# Service Bulletin

Bulletin No.: 17-NA-010

**Subject: Passenger Seat Airbag Warning Message On - DTC B0074 or B101D Set**

4920551

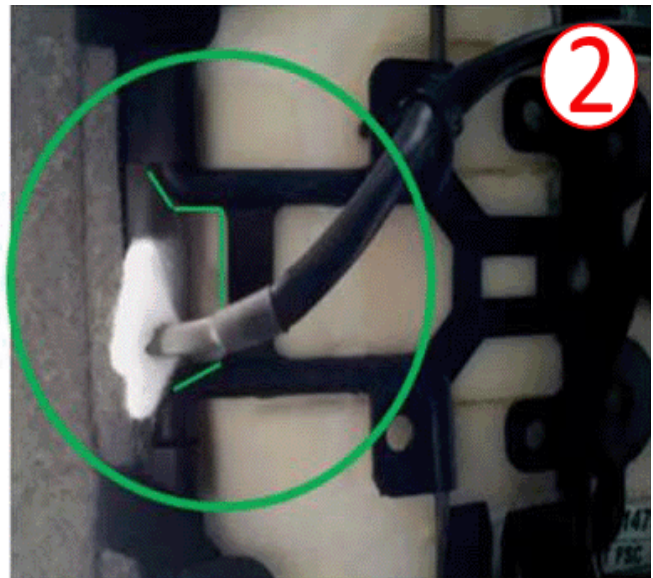
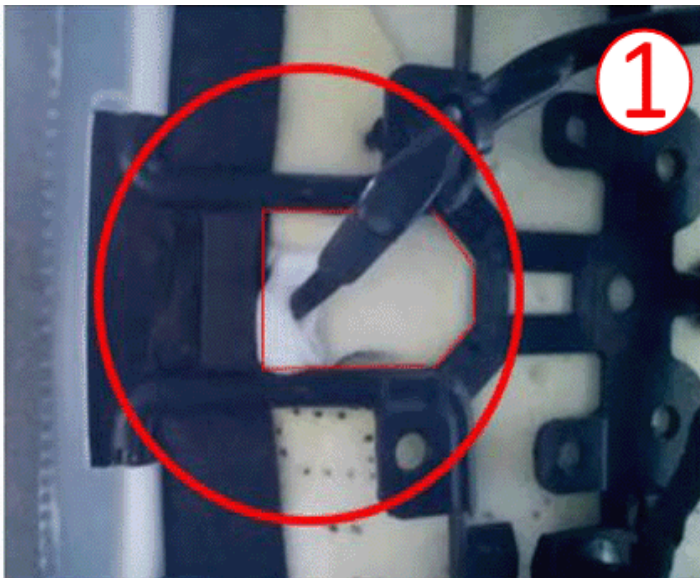
**Note:** The graphic above depicts the incorrect pigtail harness route (1) and the correct pigtail harness route after repair (2).

3. Using care, insert the PPS sensor mat pigtail (3) back through the foam opening making sure not to bend the sensor.
4. Install the cushion onto the seat frame.
  - The sensor tail must be routed through the rear suspension opening below the seat frame (2) hanging freely.
  - Validate the wiring harness (3) has proper movement.
